July 11, 2024

RE: Stride S3 Line Project

Under the circumstances, after a detailed analysis of ST data and documents and in consultation with our community, we are now formally proposing the following alternative design concept for BAT transit improvement through Lake Forest Park (see attached).

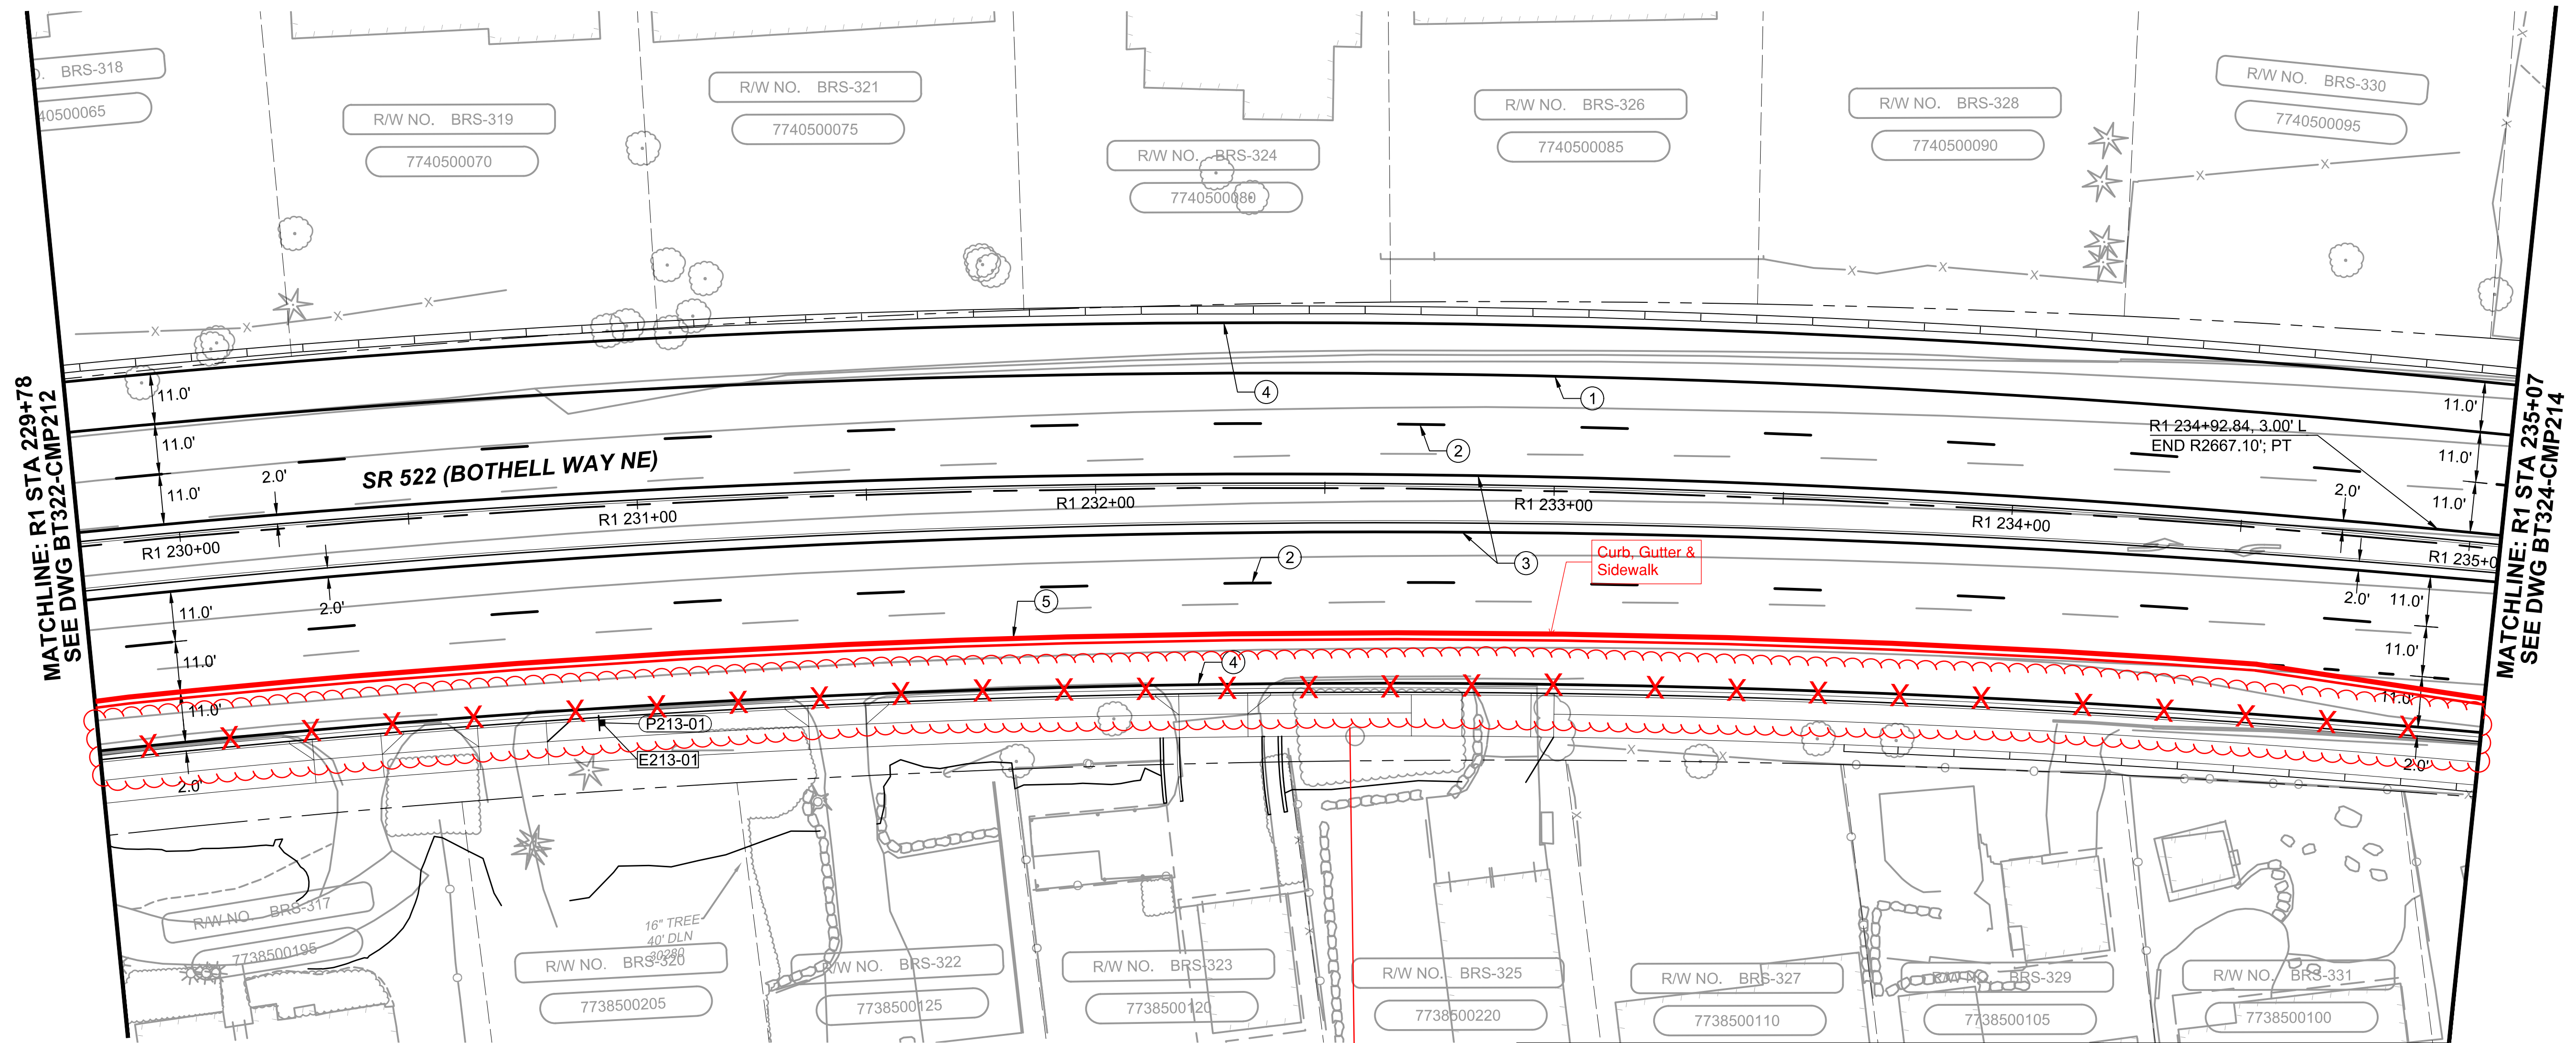
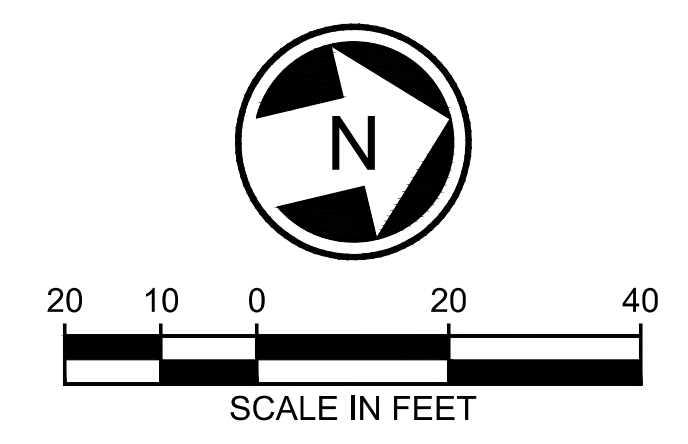
Shift sidewalk, curb, and edge of pavement improvements up to more closely align with existing roadway limits.

Suggested Modifications
 1. Revise roadway, curb, and sidewalk geometry to remove BAT lane while maintaining right turn lane to reduce ROW impacts and preserve mature vegetation as much as feasible.

DRAWING No.:
BT324-CMP214
 FACILITY ID:
BT324
 SHEET No.:
0742
 REV:

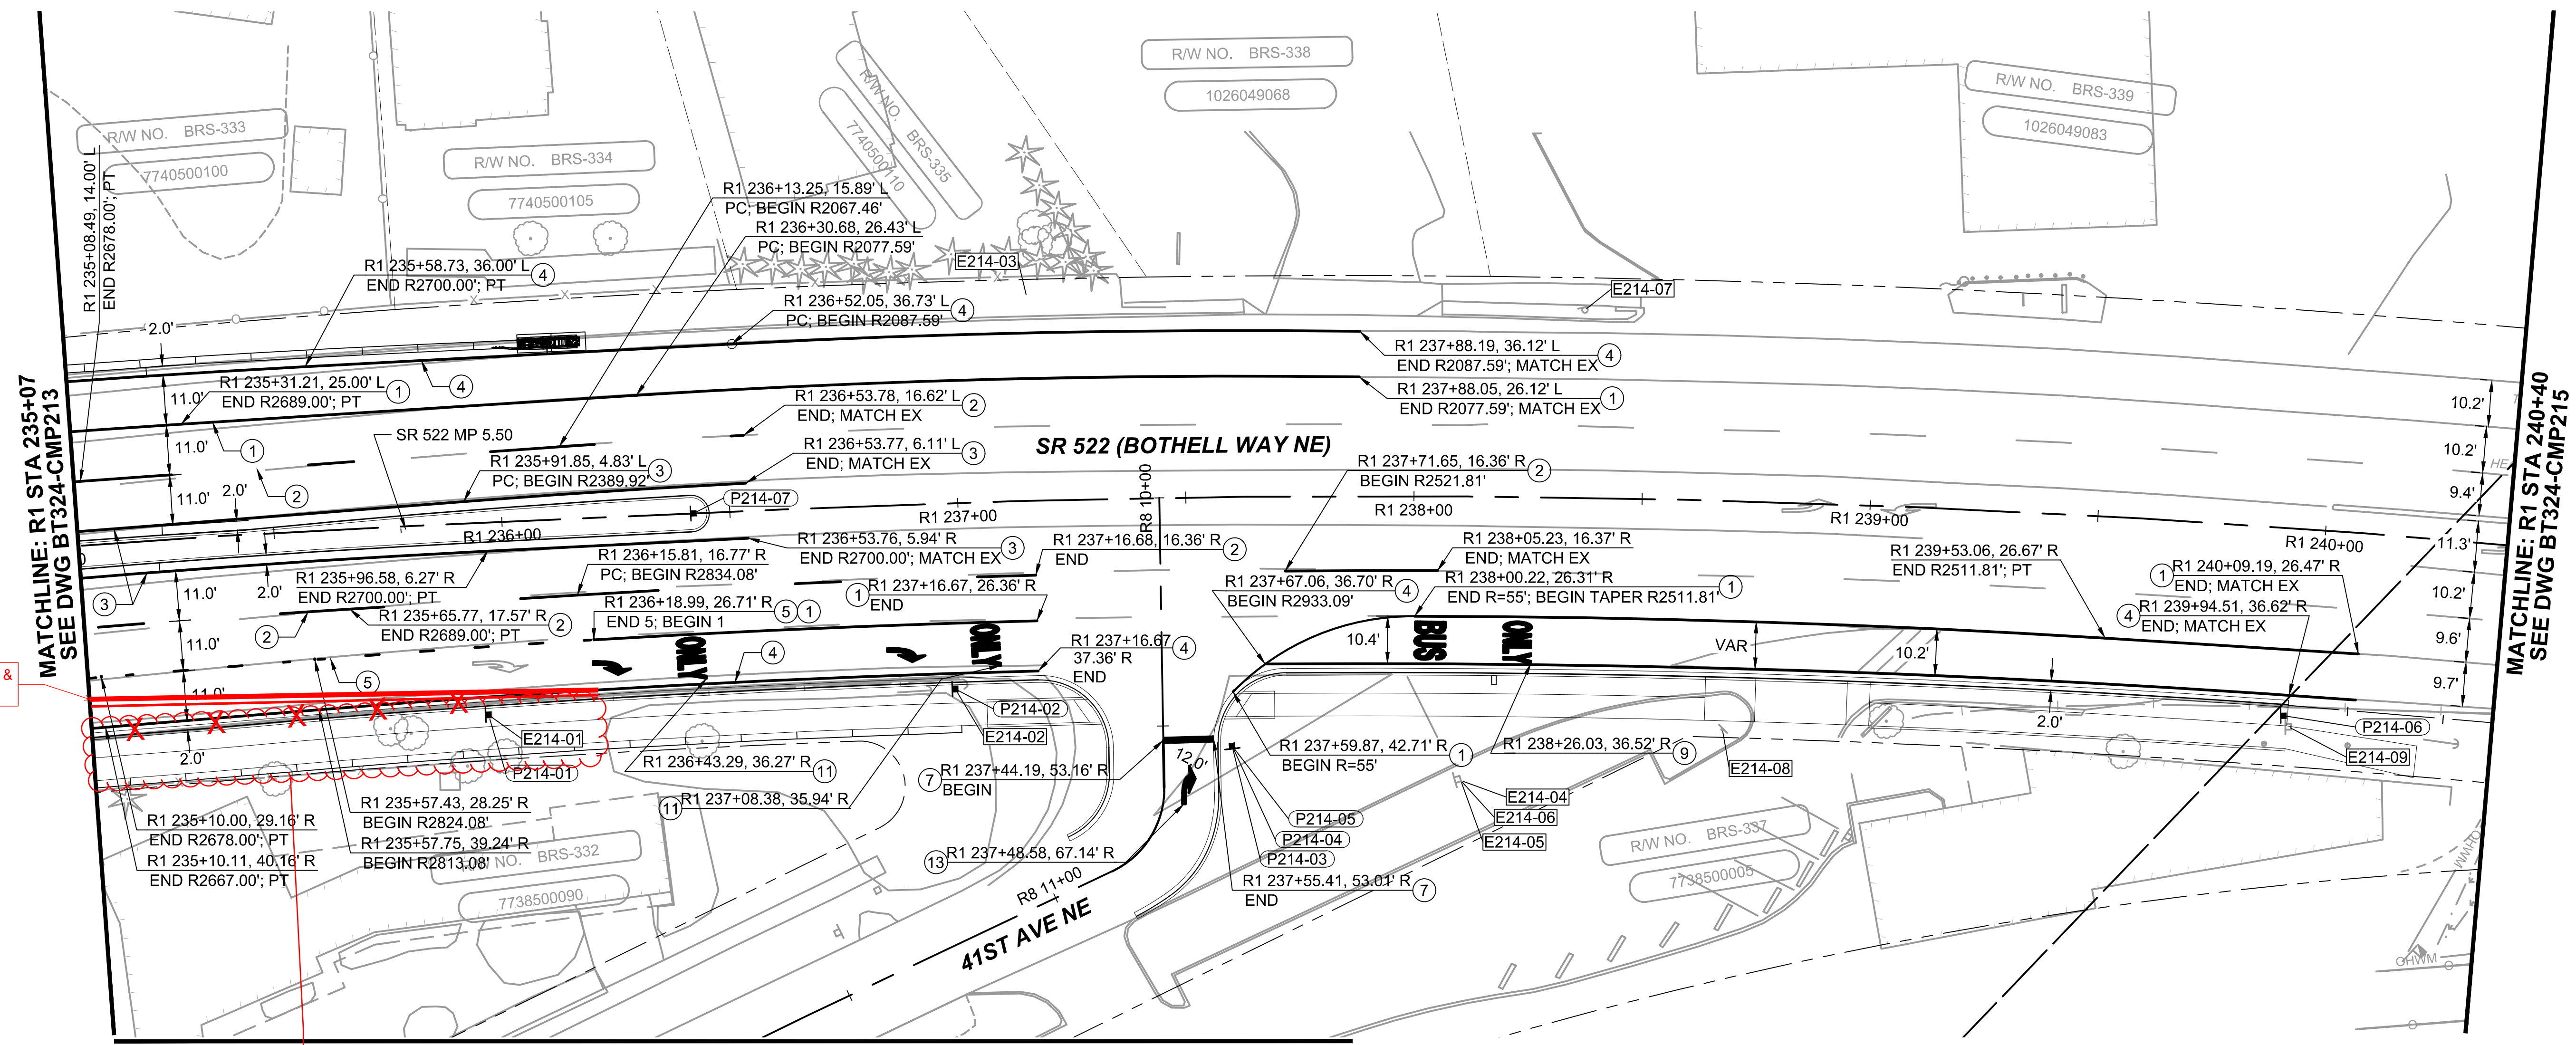
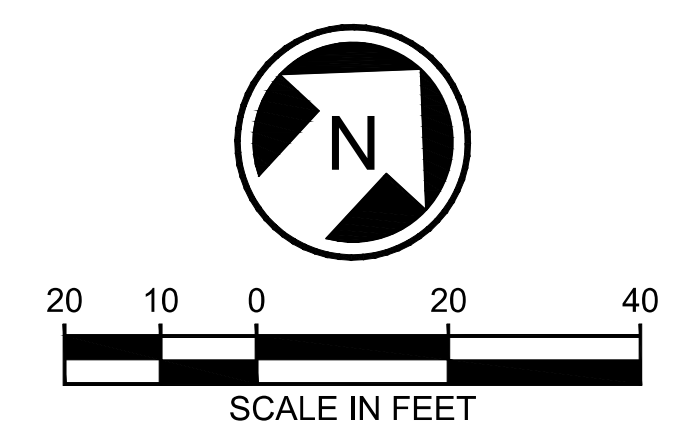
Shift sidewalk, curb, and edge of pavement improvements up to more closely align with existing roadway limits.

Suggested Modifications
 1. Revise roadway, curb, and sidewalk geometry to remove BAT lane, up to 41st Ave NE while maintaining right turn lane to reduce ROW impacts and preserve mature vegetation as much as feasible.
